## ADDENDUM # 001

**RE:** Cherokee Nation Entertainment  
Tahlequah Casino

**From:** James R Childers Architect, Inc.  
45 South 4<sup>th</sup> Street  
Fort Smith, Arkansas 72901

## Tahlequah Casino Addendum #01 summary

SHEET NUMBER: **S1.2**

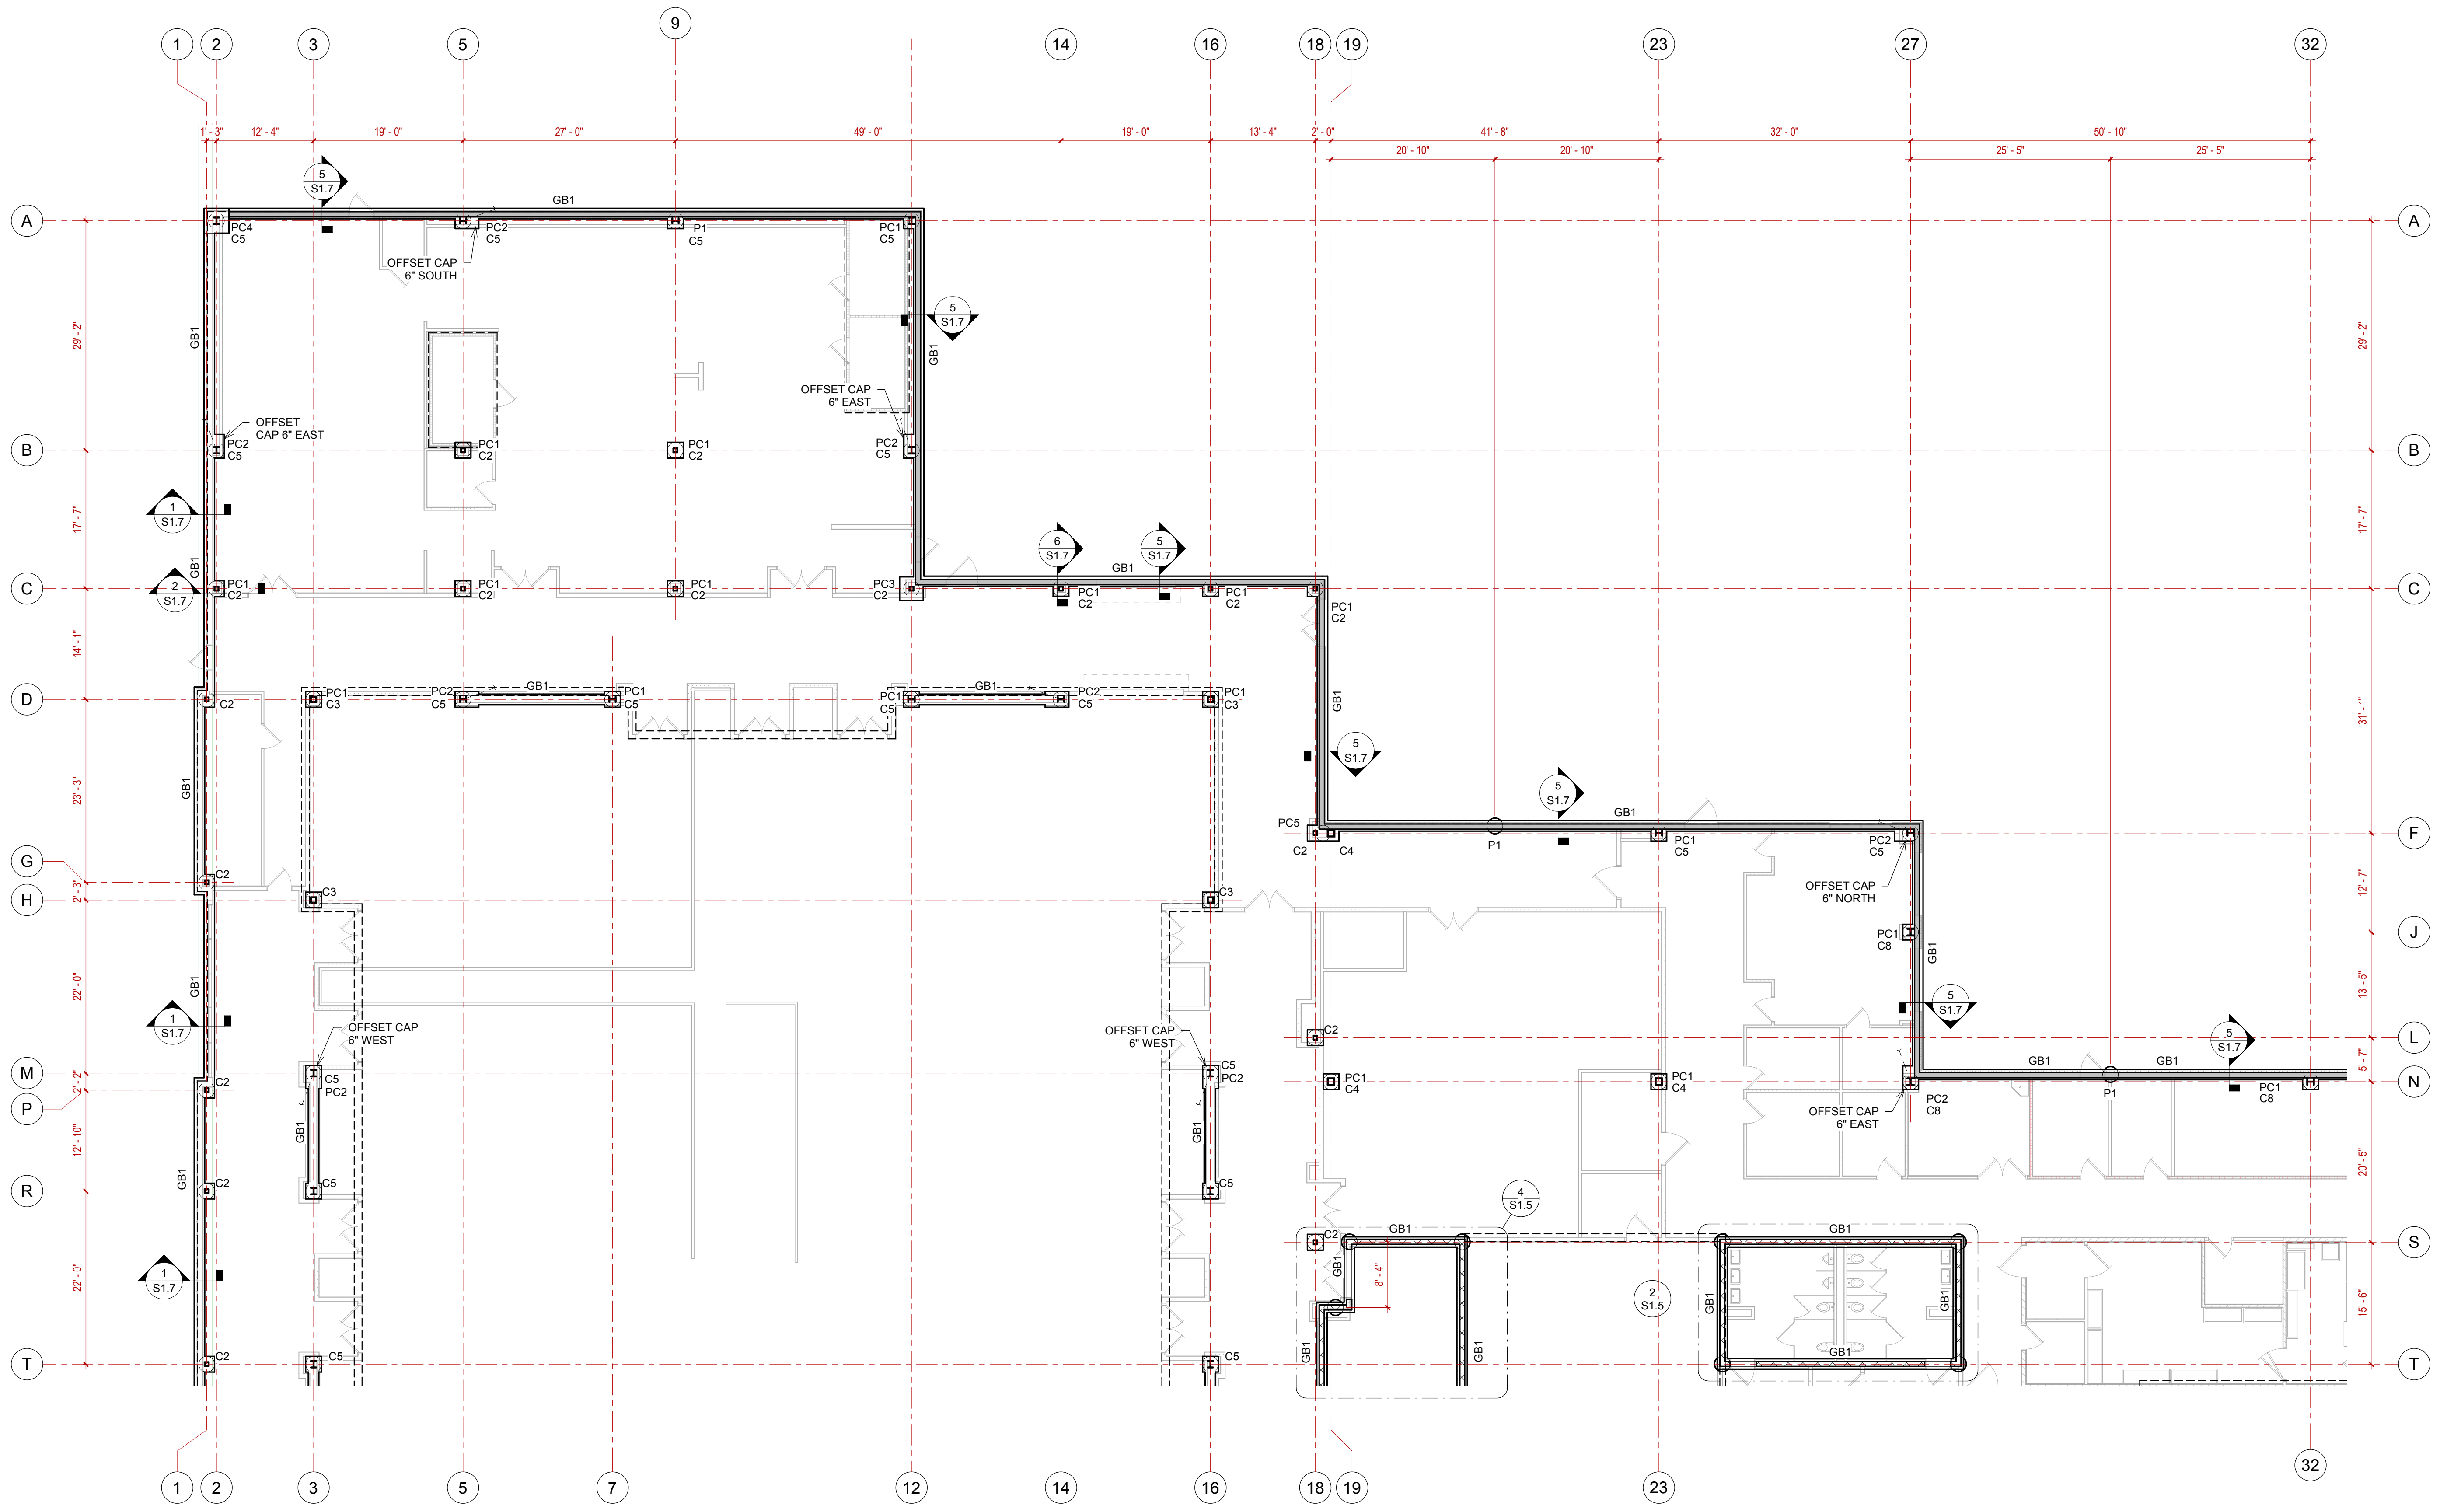
Sheet No.	Addendum
S1.2	<ul style="list-style-type: none"> <li>• Added Grade beam, pier cap, &amp; column schedules to sheet.</li> <li>• Added Grade beam, pier cap, &amp; column marks to plan.</li> <li>• Added Callouts for safer room foundation plans</li> <li>• Stepped grade beam and added curb to back of house for drainage access.</li> <li>• Added section marks to plan.</li> <li>• Changed all HSS6x6x3/16 columns to HSS6x6x1/4</li> </ul>
S1.3	<ul style="list-style-type: none"> <li>• Added Grade beam, pier cap, pedestal, &amp; columns schedules to sheet.</li> <li>• Added Grade beam, pier cap, pedestal, &amp; column marks to plan.</li> <li>• Added callouts for safer room foundation plans.</li> <li>• Stepped grade beam and added curb to front of house at sub floor locations.</li> <li>• Moved details to sheet S1.6 &amp; S1.7</li> <li>• Added section marks to plan.</li> <li>• Removed pier and column at grid U-19 &amp; U-27</li> <li>• Moved grid 'DD' 1" East</li> </ul>

SHEET NUMBER: **S1.4**

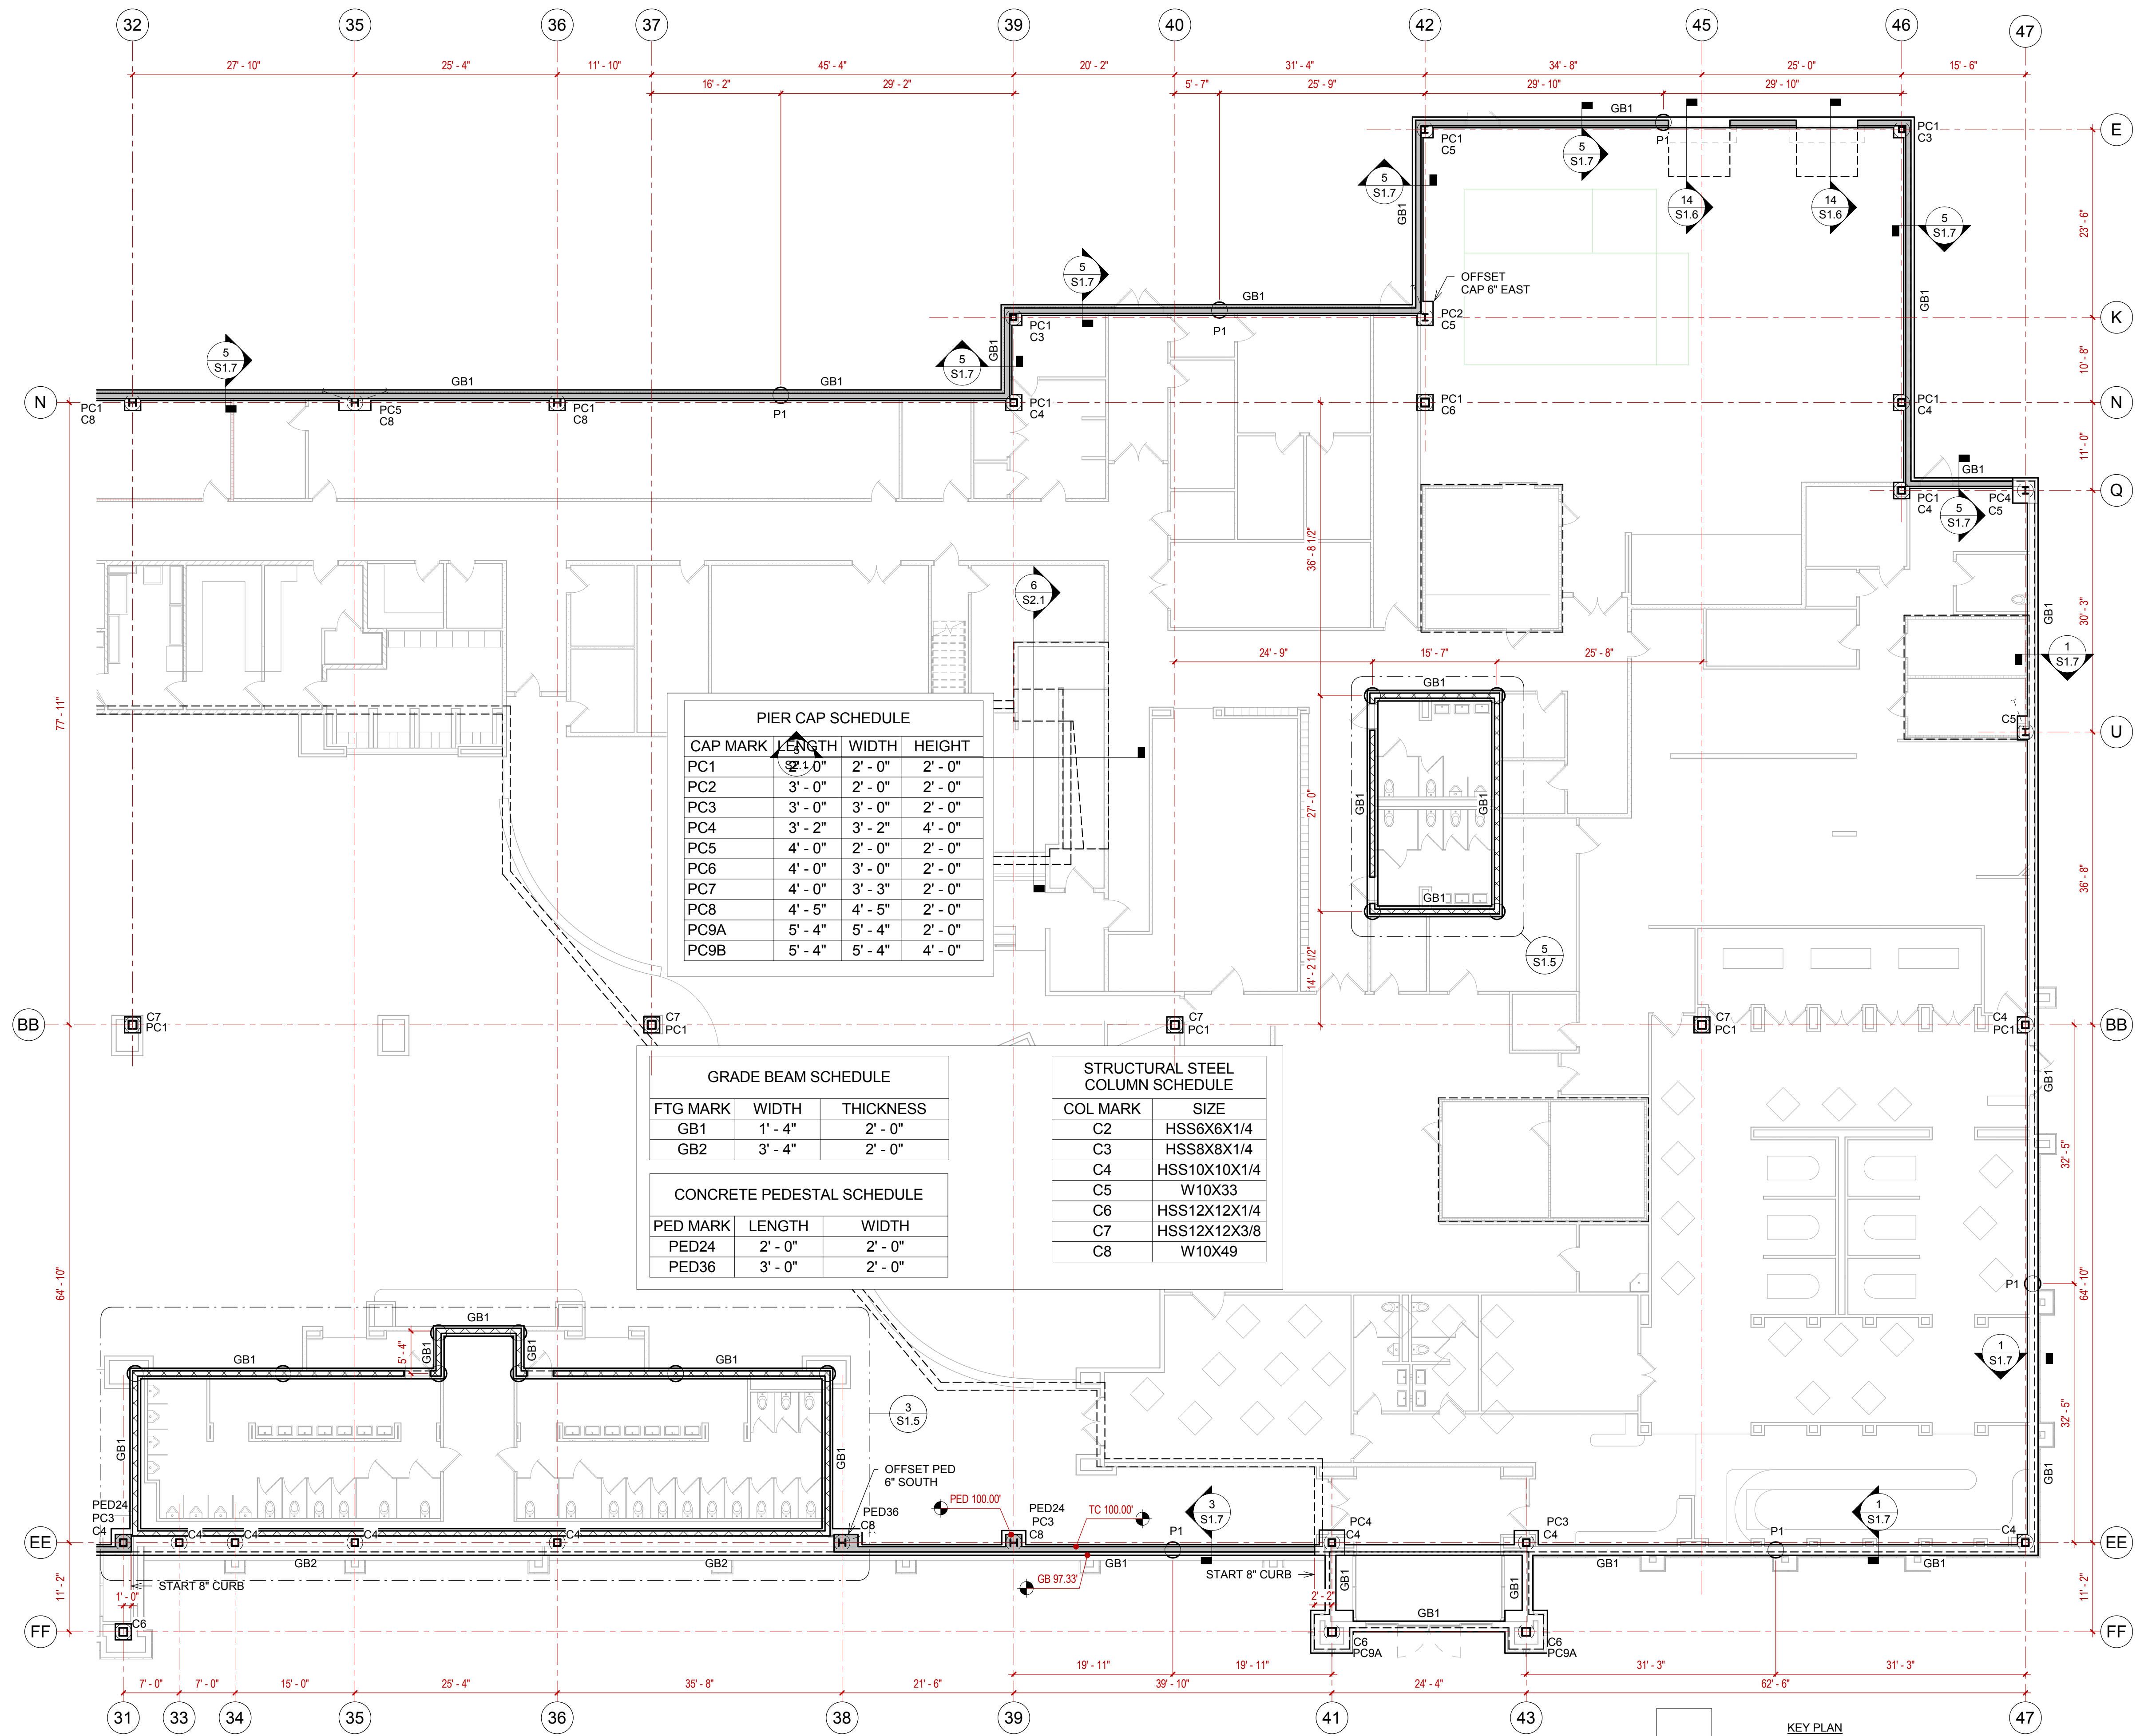
S1.4	<ul style="list-style-type: none"> <li>• Added Grade beam, pier cap, pedestal, &amp; columns schedules to sheet.</li> <li>• Added Grade beam, pier cap, pedestal, &amp; column marks to plan.</li> <li>• Added callouts for safer room foundation plans.</li> <li>• Stepped grade beam and added curb to front of house at sub floor locations.</li> <li>• Added section marks to plan.</li> <li>• Removed pier and column at grid E-44</li> </ul>
S1.5	Added sheet S1.5
S1.6	Added sheet S1.6
S1.7	Added sheet S1.7
S2.1	<ul style="list-style-type: none"> <li>• Added enlarged stage pit plan and sections.</li> <li>• Added pit for dock levelers.</li> </ul>
S3.1	<ul style="list-style-type: none"> <li>• Revised roof deck to galvanize.</li> <li>• Revised column sizes.</li> </ul>
S3.2	<ul style="list-style-type: none"> <li>• Moved brace elevation from Y/BB-19 to U/BB-21</li> <li>• Moved frame line 'DD' 1" east</li> <li>• Revised roof deck to galvanize.</li> <li>• Removed column @ U-19 &amp; U-27.</li> </ul>
